This meeting of the Grimes Planning and Zoning Commission was called to order Tuesday January 7, 2020 at 5:30 P.M. at Grimes City Hall.

The Development Services Department is in receipt of a proposed Site Plan for Destination Market Plat 4. Based on the review of the provided submittal materials, staff have the following comments:

Planning & Zoning Staff Report

The Development Services Department is in receipt of a proposed Site Plan for KinderCare. Based on the review of the provided submittal materials, staff have the following comments:

Sheet C500

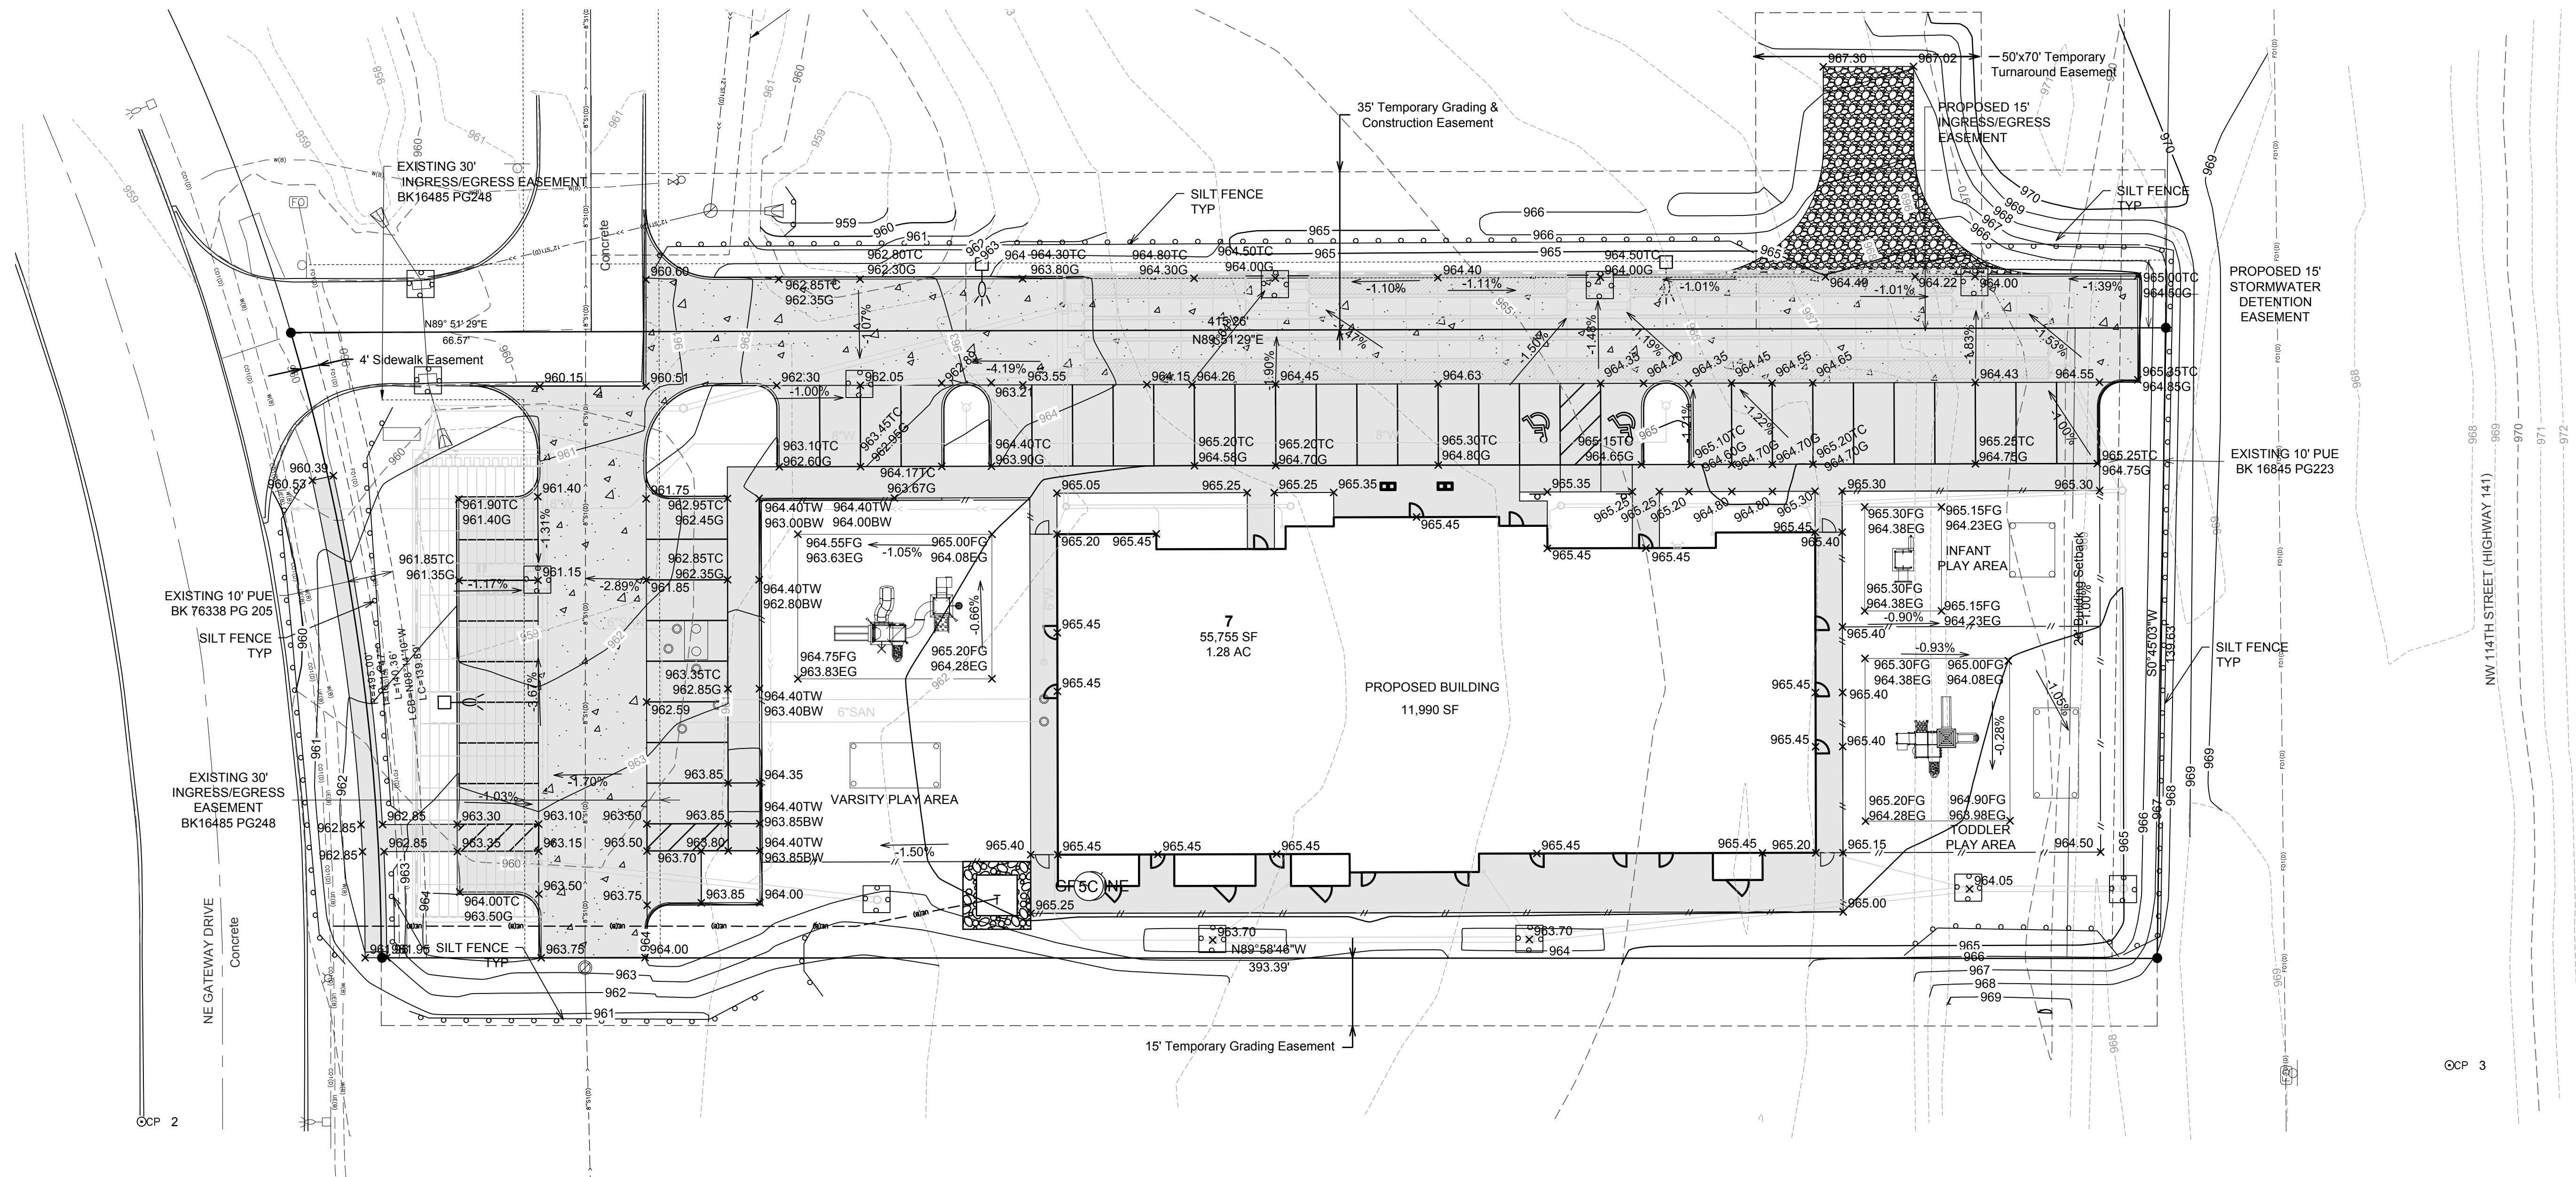
- ~~19. Several areas with overlapping text. Please fix.~~
20. **Reconcile Structures ST-2a and ST-10. Details and site plan do not match. Are these structures nyloplast, or concrete? Reconcile Structures ST-2a and ST-10. Details have not been fixed. Inverts do not match, and pipe materials and sizes don't match site plan and Stormtech sheets.**
- ~~21. Is there a subdrain for the building? Where are the downspouts connecting to the storm sewer?~~

24. Please identify the location of the FDC. Note that it must be accessible with a clear and open path (no parking stall in front. It must also be within 100-feet of a hydrant. **FDC is not remote, and has parking in front of it. Please revise.**

- 27. Please note that the building will need to be outfitted with a fire suppression system. As such, please show the required 6" fire service into the building.**

28. Please use 6" PVC SDR 23.5 service for commercial building services. **Revise to 6"**
- ~~29. The tap to the existing sanitary is to be completed utilizing a Romac Saddle or approved equal. Note that the existing main is to be tested and video inspected at the tap location~~

- 32. Pipe P-5B slope should be 0.6% as shown being required on SWMP.**
- 33. ST-5B needs invert for 8" HDPE**
- 34. Please relocate the hydrants into the islands to provide better access.**
